## 34401A-15B

# <u>SERVICE NOTE</u>

34401A - Multimeter

10 megohm and 100 megohm ranges drift out of specification

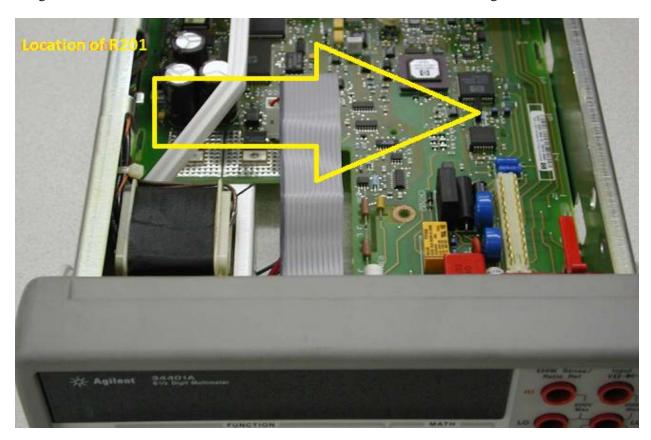
**Customers World-Wide:** Customers with technical ability to replace this resistor may replace the resistor themselves. (Note: A1R201 is a through-hole resistor located between A1U101 and A1U150 on the 34401A main PC assembly.) This approach will provide the minimum instrument downtime and inconvenience.

Locate and remove A1R201. Replace A1R201 and solder into position. Trim leads. Reassemble the 34401A and connect power. Power on the 34401A and allow it to warm up for 4 hours. Perform the Gain Adjustment Procedure found in Chapter 4 of the 34401A Service Manual for the 10 MOhm Range. Perform the Gain Verification Test for the 10 MOhm and 100 MOhm ranges.
